Technical product information

| Topic | Driver/Passenger door/s creak on close |

Bentayga

Figure 1

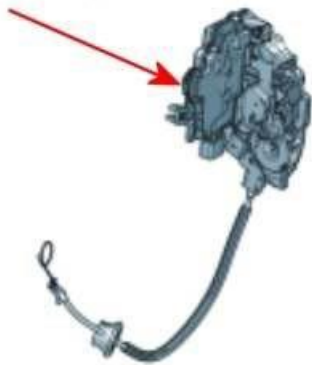
Refer to the vehicle repair history to check/confirm if any previous work which has been conducted regarding door latch replacement (Figure 1)

In the event the door latch date of manufacture is unknown (No notes within the vehicle repair history) the date of manufacture of each door latch must be confirmed

Figure 2

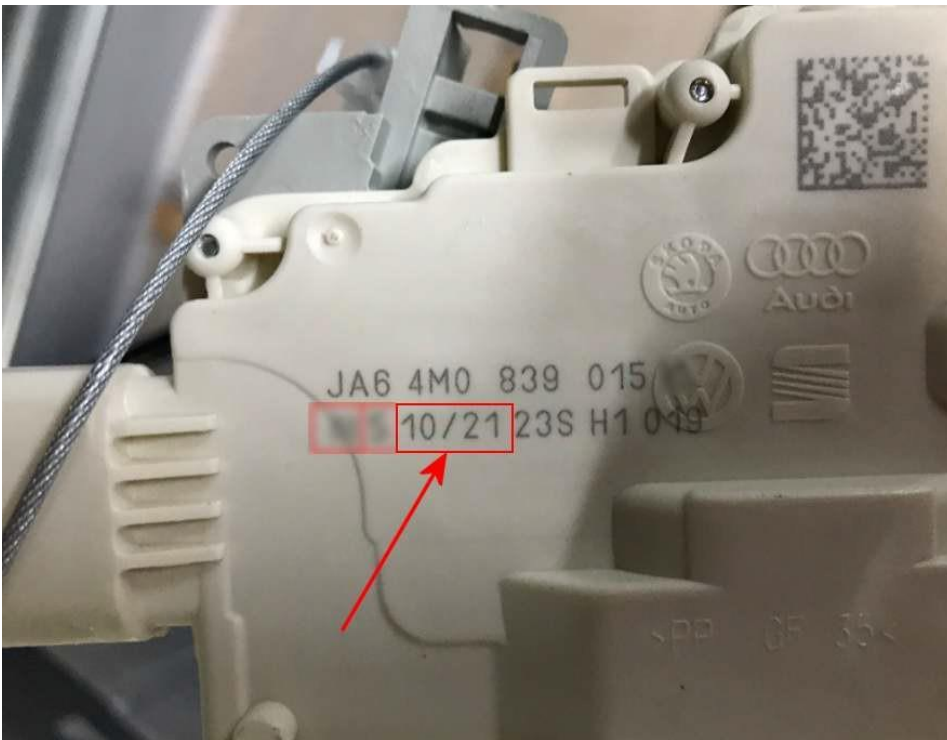
- 1) Referring to the applicable Rep.Gr - Remove the front and rear door trims
- 2) Referring to Figure 2 - Check the date of manufacture in the location shown

[Latch manufacturing date code prior to 10/21](#)

[Latch manufacturing date code post 10/21 or 22 Model year](#)

- Referring to the applicable Repair Group - Replace all latch motors to latest specification

- Referring to the applicable Repair Group - Replace the faulty door latch only
